**From:** [Sebrosky, Joseph](#)  
**To:** [Roth\(OGC\), David](#); [Harris, Brian](#); [Young, Mitzi](#); [Kanas, Catherine](#)  
**Cc:** [Oesterle, Eric](#); [Markley, Michael](#)  
**Subject:** FW: Did PG&E and the NRC work together to spin news on Diablo Canyon quake safety? attorney client  
**Date:** Friday, September 19, 2014 6:36:20 AM

**From:** [Oesterle, Eric](#)  
**To:** [Whited, Jeffrey](#)  
**Cc:** [Markley, Michael](#); [Lund, Louise](#); [Wilson, George](#)  
**Subject:** Additional Q&As for Diablo Canyon  
**Date:** Tuesday, November 25, 2014 12:37:05 PM  
**Attachments:** [ANTICIPATED QUESTIONS AND ANSWERS DCPD.docx](#)  
[image001.png](#)

TECHNICAL EVALUATION REPORT BY THE OFFICES OF NEW REACTORS,  
RESEARCH, AND NUCLEAR REACTOR REGULATION  
CENTRAL COASTAL CALIFORNIA SEISMIC IMAGING PROJECT  
PACIFIC GAS AND ELECTRIC COMPANY  
DIABLO CANYON POWER PLANT, UNITS 1 AND 2  
October 21, 2014, 8:00 am version

Figure 1 - Deterministic Response Spectrum Single Station Approach

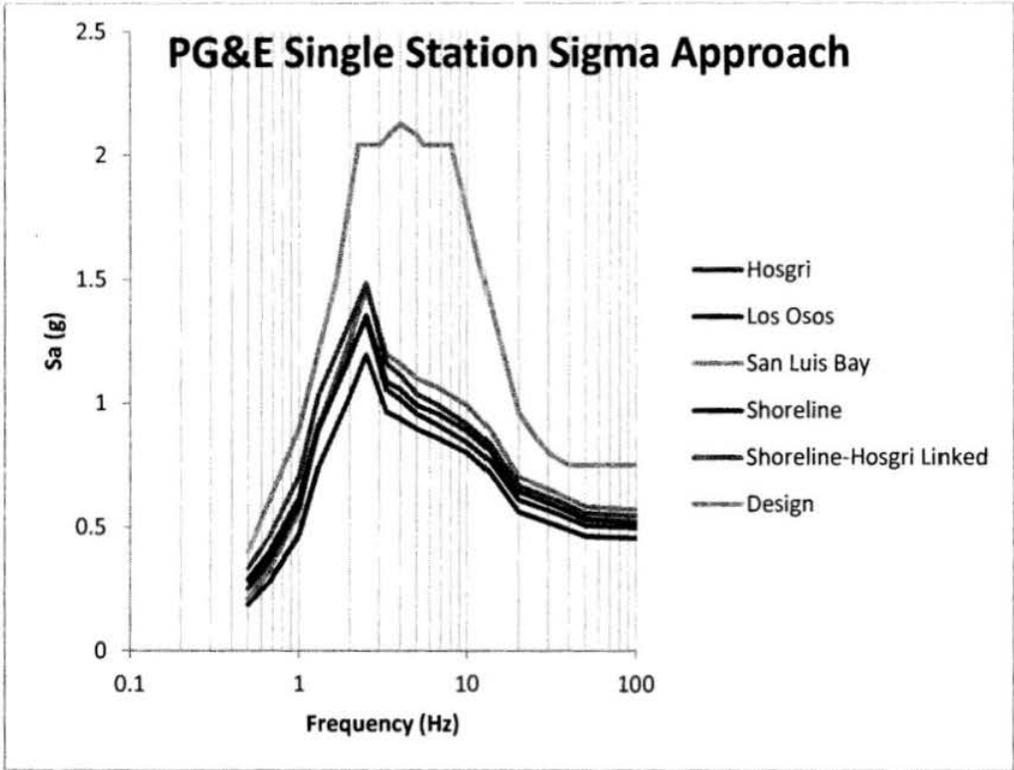
Figure 1 of this evaluation provides a plot of the deterministic response spectrum using the source characteristics of various faults and the NGA West2 GMPEs for the power block (Note: need to confirm if these NRC generated plots are for the power block or the turbine foundations)

This correction was applied by PG&E but was not required for the confirmatory analysis that the NRC conducted as documented in RIL 12-01. The curves found in CCCSIP Chapter 13 found in Figure 1 of this evaluation are based on a single station correction and do not reflect ergodic uncertainty. As a result of questions raised during the inspection of PG&E's operability determination PG&E provided the following information relative to its use of the single-station-sigma correction on September 25, 2014:

Figure 2 - Deterministic Response Spectrum NRC Developed Ergodic Approach

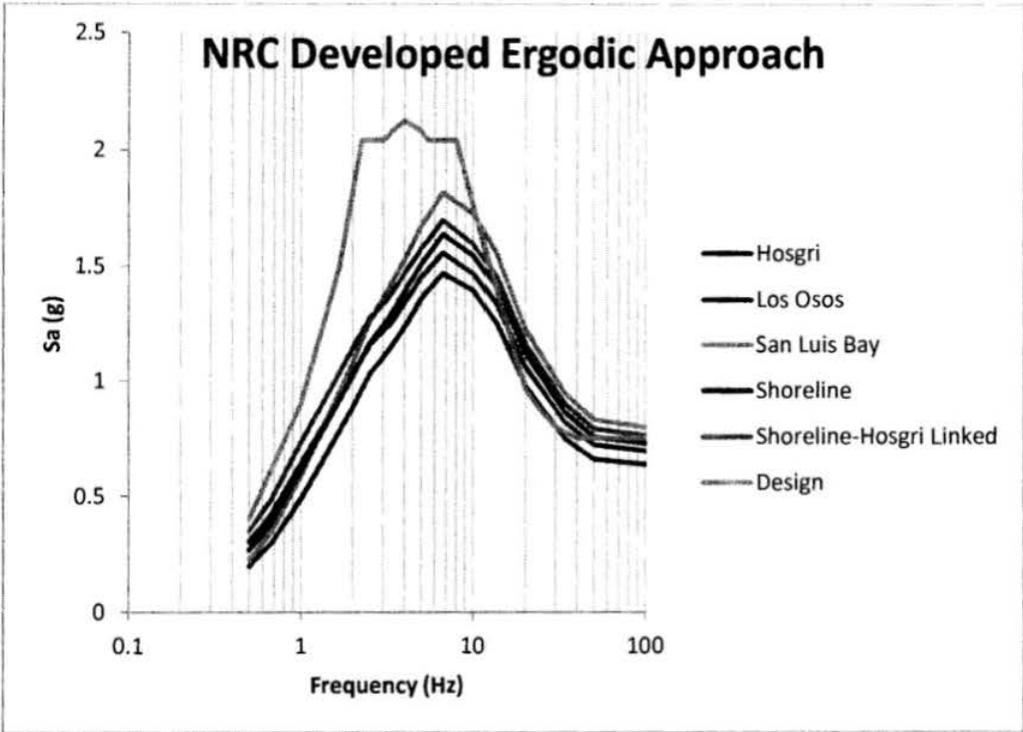
Using the information provided by PG&E, the NRC staff developed the ergodic curves found in Figure 2 of this document.

However, the NRC staff notes that based on the NRC staff developed ergodic curves found in Figure 2, below that there are exceedance in the 10 Hz to 100 Hz range for the ground motions from the earthquakes evaluated in the CCCSIP 2014 report. The evaluation of the exceedances in this range can be found in Section 3.4 of this document.

As stated above, PG&E's 2014 CCCSIP report included an evaluation of the ground motion response spectrum compared to the 1977 HE ground motion based on the single-station-sigma approach. While the staff concludes that the single-station-sigma approach has its benefits, the staff nevertheless also developed on its own the ground motion response spectrums for the faults that were analyzed in the 2014 CCCSIP report using the more traditional treatment of uncertainties (i.e., the ergodic approach). The ground motion response curves for the various fault scenarios based on the ergodic approach can be found in Figure 2 of this document.

Figure 1 - Deterministic Response Spectrum Single Station Approach

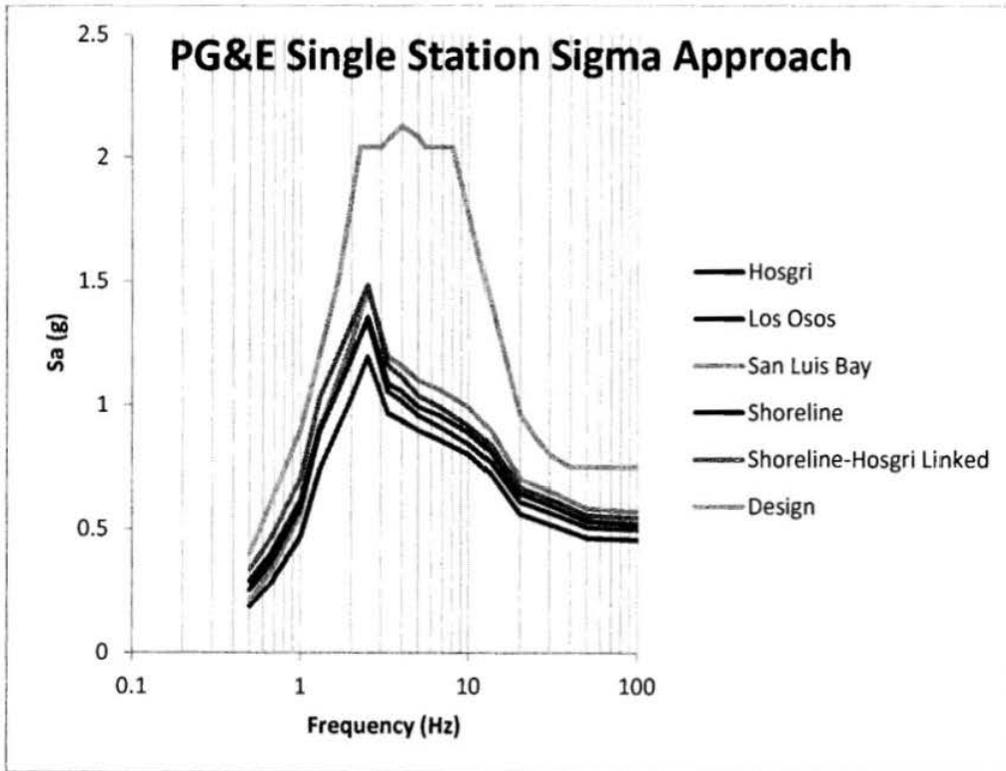
Figure 1 of this evaluation provides a plot of the deterministic response spectrum using the source characteristics of various faults and the NGA West2 GMPEs for the power block (Note: need to confirm if these NRC generated plots are for the power block or the turbine foundations)

This correction was applied by PG&E but was not required for the confirmatory analysis that the NRC conducted as documented in RIL 12-01. The curves found in CCCSIP Chapter 13 found in Figure 1 of this evaluation are based on a single station correction and do not reflect ergodic uncertainty. As a result of questions raised during the inspection of PG&E's operability determination PG&E provided the following information relative to its use of the single-station-sigma correction on September 25, 2014:

Figure 2 – Deterministic Response Spectrum NRC Developed Ergodic Approach

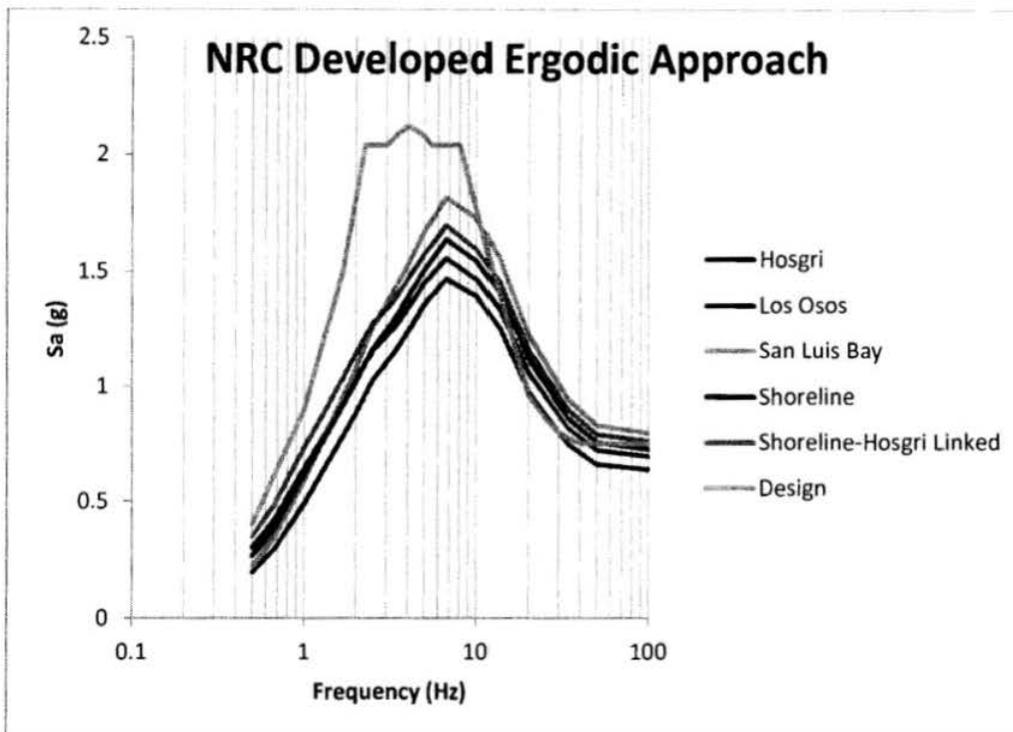
Using the information provided by PG&E, the NRC staff developed the ergodic curves found in Figure 2 of this document.

However, the NRC staff notes that based on the NRC staff developed ergodic curves found in Figure 2, below that there are exceedance in the 10 Hz to 100 Hz range for the ground motions from the earthquakes evaluated in the CCCSIP 2014 report. The evaluation of the exceedances in this range can be found in Section 3.4 of this document.

Figure 1 - Deterministic Response Spectrum Single Station Approach

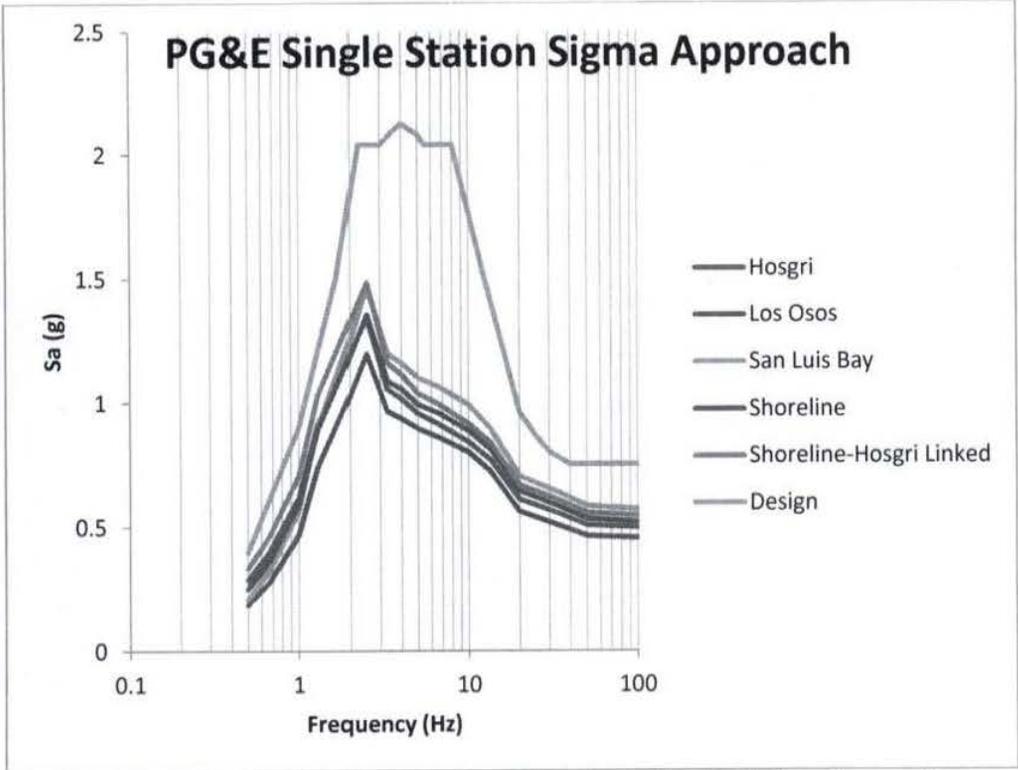
Figure 1 of this evaluation provides a plot of the deterministic response spectrum using the source characteristics of various faults and the NGA West2 GMPEs for the power block (Note: need to confirm if these NRC generated plots are for the power block or the turbine foundations)

This correction was applied by PG&E but was not required for the confirmatory analysis that the NRC conducted as documented in RIL 12-01. The curves found in CCCSIP Chapter 13 found in Figure 1 of this evaluation are based on a single station correction and do not reflect ergodic uncertainty. As a result of questions raised during the inspection of PG&E's operability determination PG&E provided the following information relative to its use of the single-station-sigma correction on September 25, 2014:

Figure 2 - Deterministic Response Spectrum Ergodic Approach

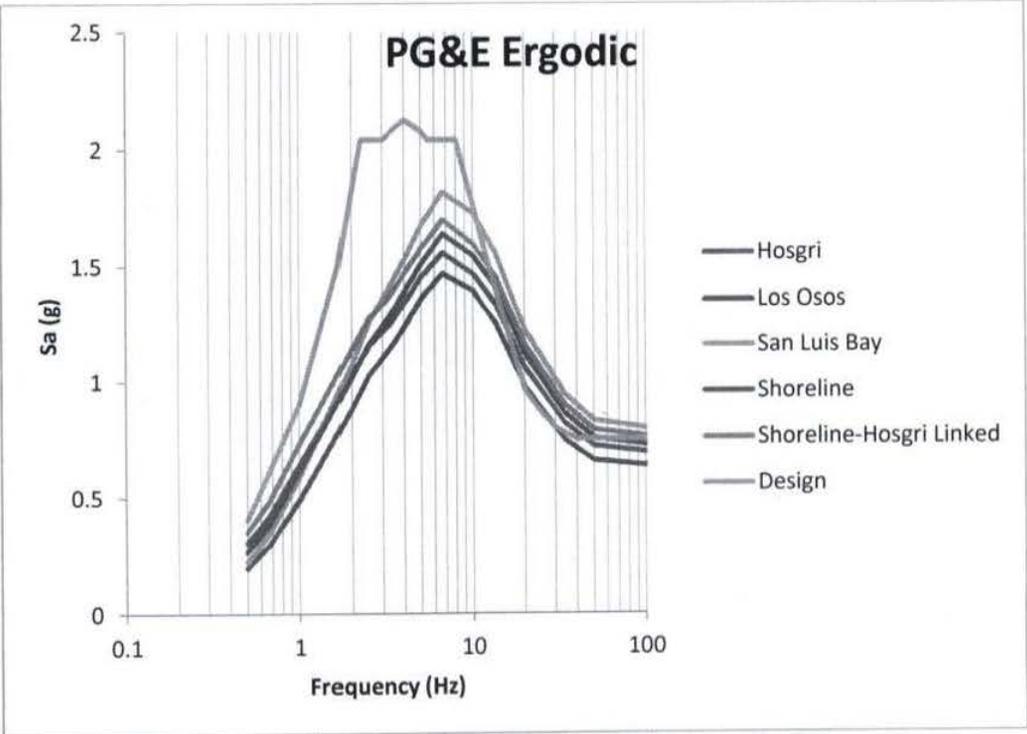
Using the information provided by PG&E, the NRC staff developed the ergodic curves found in Figure 2 of this document.

However, the NRC staff notes that based on the NRC staff developed ergodic curves found in Figure 2, below that there are exceedance in the 10 Hz to 100 Hz range for the ground motions from the earthquakes evaluated in the CCCSIP 2014 report. The evaluation of the exceedances in this range can be found in Section 3.4 of this document.
